**Subject:** Flow Sensor Tier 2 Changes  
**Creation Date:** Mon, Oct 31, 2005 3:35 PM  
**From:** "Lindgren, Donald A." <lindglda@westinghouse.com>

**PROPOSED REVISION 15**  
**AP1000 DESIGN CONTROL DOCUMENT**

**Reactor Coolant System Flow Sensor**

**Description of Change**

15.3.1-2

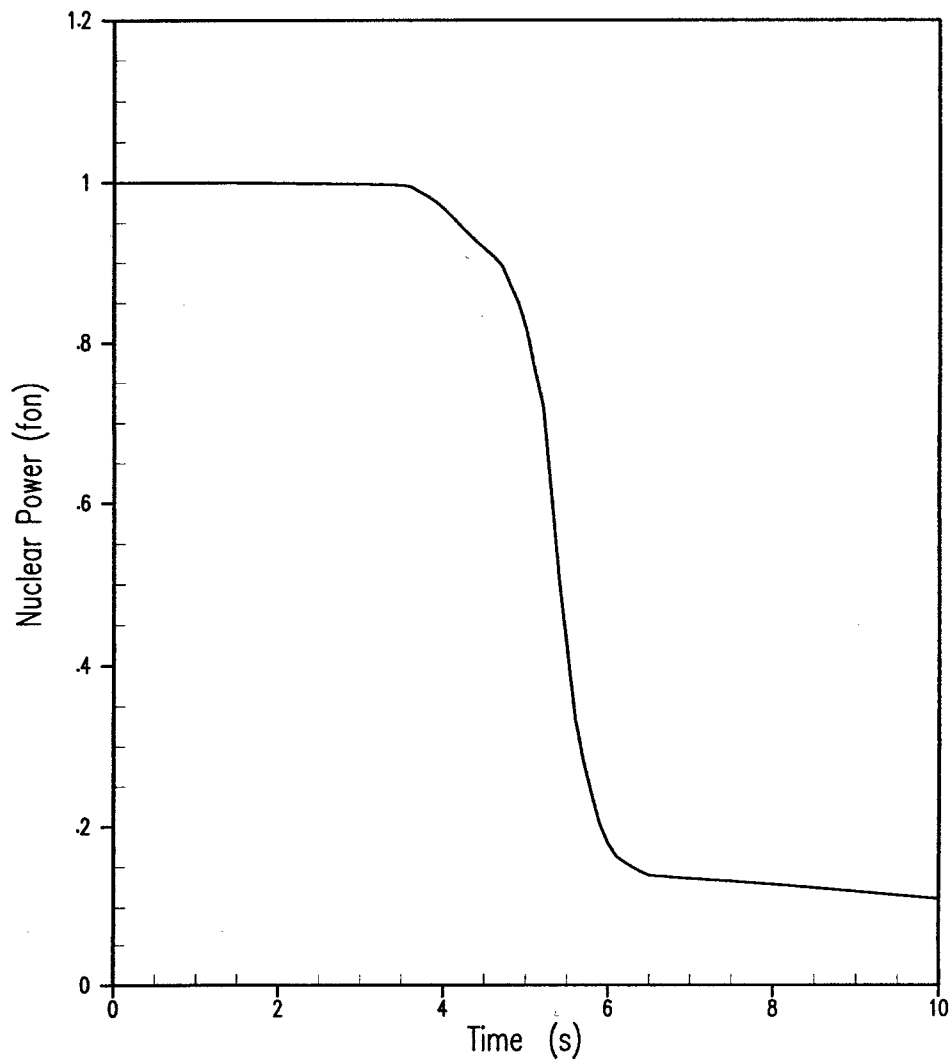
References in Tier 2 text and tables to the cold leg flow signals are also changed to hot leg signals to be consistent with Tier 1 changes. Chapter 15 Figures related to analysis of partial loss of forced reactor coolant flow and the locked rotor event are also revised. The RCS loop layout, RCS P&ID, and the protection system functional diagram that show the flow instruments are revised.

There is a small impact on the analysis results of partial loss of forced reactor coolant flow (Subsection 15.3.1) since reactor trip will be on low hot leg flow instead of low cold leg flow. Since AP1000 hot leg flow is the total of two cold legs, the reactor trip will be somewhat slower (less sensitive to trip of a cold leg pump). The acceptance criteria for the partial loss of flow event continue to be met with margin. The more limiting complete loss of forced reactor coolant flow event (Subsection 15.3.2) is not impacted. There is a very small impact on the locked rotor event (Subsection 15.3.3), but the acceptance criteria continue to be met with a wide margin. The time for the hot leg to drop to 87% flow is approximately 1.0 seconds slower for a trip of two reactor coolant pumps, and approximately 0.067 seconds slower for a locked rotor.

Replace Figures 15.3.1-2 through 15.3.1-6 with the following figures

Figure 15.3.3-3

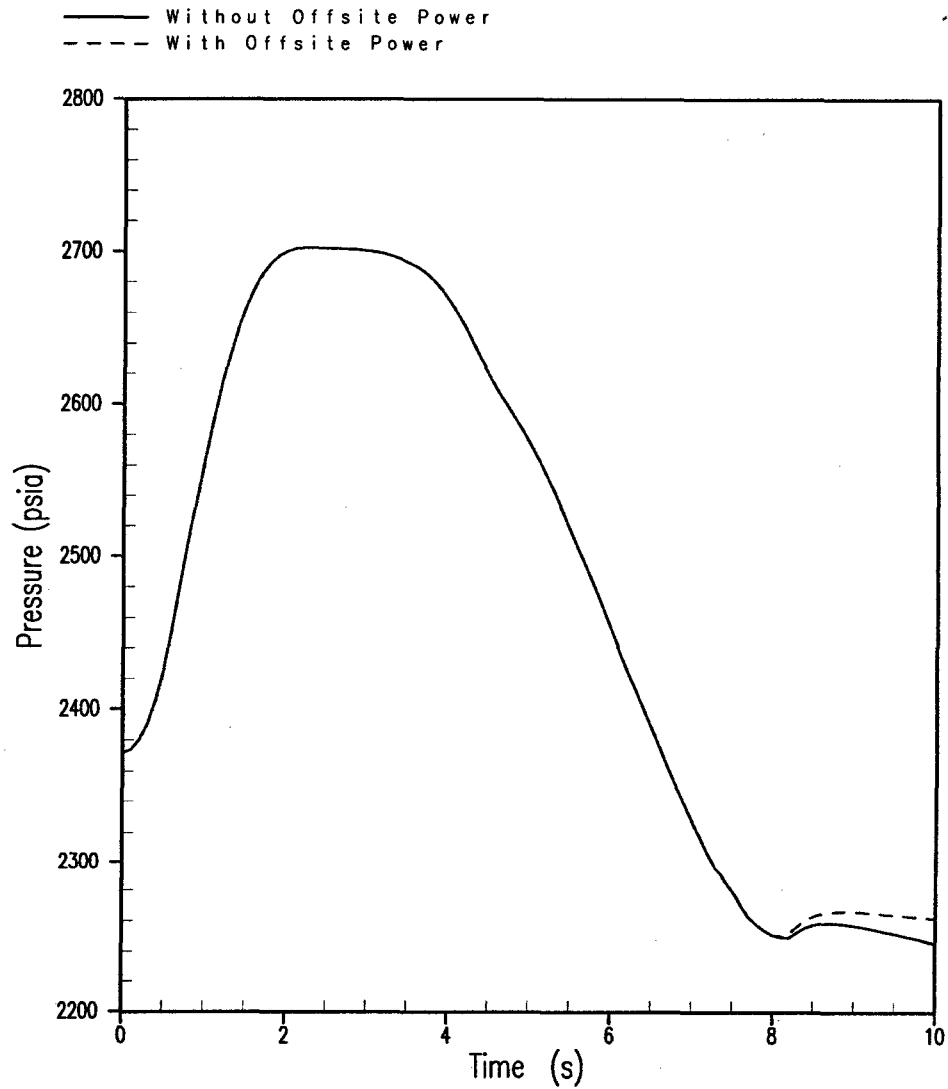
Replace Figures 15.3.3-3 through 15.3.3-7 with the following figures:
